In re U.S. Patent Application of:	:	
	)	
Jan Abraham VAN ASSELT	:	Atty. Ref: 115692-00101
	)	
Serial Number: 09/980,092	:	Group Art Unit: 3711
	)	
Filed: February 11, 2002	:	Examiner: Alvin A. Hunter
	)	
For: BALL GAME APPARATUS	:

**APPEAL BRIEF**

**COPY OF JULY 25, 2003, OFFICE ACTION  
FINALLY REJECTING PENDING CLAIMS**

FIG. 1

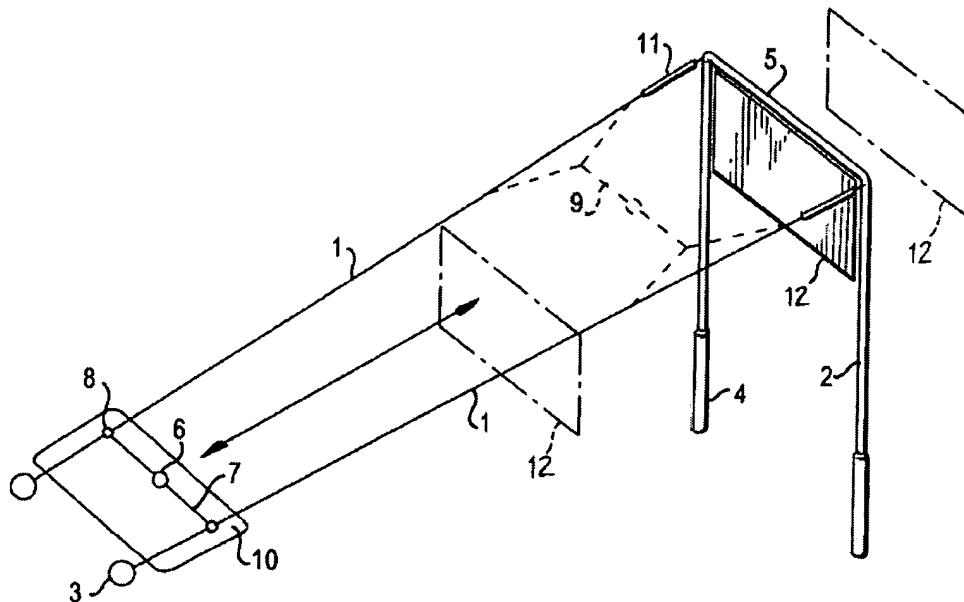
What is the minimum spacing and maximum spacing of the guideways? What is the buffering and/or deflector means? How is the tension mechanism used? How is the inclination varied? The above are just a few questions showing that the specification does not make it clear as how to make the invention.

2. The disclosure is objected to because of the following informalities: Specification should be amended to show reference numbers to the target and backboard within the drawings.

one skilled in the art to which it pertains, or with which it is most nearly connected, to make and/or use the invention. What is the minimum spacing and maximum spacing of the guideways? What is the buffering and/or deflector<sup>28</sup> means? How is the tension<sup>26+27</sup> mechanism used? How is the inclination<sup>19</sup> varied? The above are just a few questions showing that the specification does not make it clear as how to make the invention.

As disclosed in the specification, the guideways diverge. See Figure 1. Thus, the spacing between the guideways at the anchorages/pegs 3 is less than the length of the substantially inelastic line 7. Moreover, the spacing between the guideways at the supports 2 is greater than the length of the substantially inelastic line 7. The minimum and maximum spacing between the guideways is dictated by the length of the substantially inelastic line 7 and (vice versa) by the fact that the guideways diverge. This divergence of the guideways 1 and the relative spacing of the ends of the guideways with respect to the length of the substantially inelastic line 7 is clearly illustrated in Figure 1 above. However, the actual minimum and maximum values, or ranges of values, is irrelevant for purposes of enabling one of ordinary skill in the art to make and/or use the invention.

Clearly, the minimum spacing of the guideways 1, at the point where they connect to the anchorages/pegs 3, is approximately the diameter of the ball 6. However, the specification describes how a player “...stands near the lowermost end of the guideways 1 at their point of connection to the ground pegs 3...” and strikes the ball. Clearly, the player will most likely stand outside the guideways 1 to avoid contacting the substantially inelastic line 7. One of ordinary skill in the art, therefore, reading that part of the specification, would understand that the ball 6 must be placed at a position where a player standing outside the guideways 1 holding a golf club can strike the ball 6. That position can be estimated based on knowledge of a typical golf player’s stance over a golf ball and the length of a typical golf club. Thus, the minimum spacing of the guideways 1 can be greater than the diameter of the ball 6 as long as a player can reach the ball with a golf club. Thus, the specification provides additional disclosure from which one of ordinary skill in the art can determine the minimum spacing of the guideways 1 without undue experimentation. For the same reasons, an approximate length of the substantially inelastic reciprocating line can be determined.

With regard to the maximum spacing of the guideways at the point where they connect to the supports 2, it is clear from the specification that after the ball 6 is struck by a player and the ball 6 and the substantially inelastic line 7 traverse along the guideways, the distance between the ends of the substantially inelastic line 7 becomes the same as the distance separating the guideways 1 so that the substantially inelastic line 7 stops and is deflected back to along the guideways 1 to the player. Thus, when

The tensioning device is fully described in the application. Application at 3, fifth paragraph. It is also shown, in one embodiment of the invention, on Figure 1 by

reference number 11. As described in the specification, the guideways can be maintained taut between the ground anchorages/pegs 3 and the top of the stable supports 2 by the tensioning device 11. In one embodiment of the invention, the tensioning device is a simple reel attached near the stable support (or near the anchorages) as shown in Figure 1. Such reels are well known and simply comprise a mechanism that enables one to shorten or lengthen the effective length of a line thereby varying the tension in the line.

With regard to how the inclination is varied, the specification discloses the structure and function of the mechanism for varying the inclination of the guideways 1. Application at 6, first paragraph (lines 5 and 6). Specifically, the specification describes that the height of each support 2, held vertical by assistance of metal supports 4, is “adjustable.” Adjusting the height of the top of the stable supports is one method of adjusting the inclination of the guideways in the embodiment shown in Figure 1.

invention disclosed in the specification, specifically how it can be manipulated to incline the guideways as shown in Figure 1. As noted above, the inclination can simply be varied by increasing or reducing the distance between the anchorages/pegs 3 and the supports 2, or by varying the height of the supports 2.
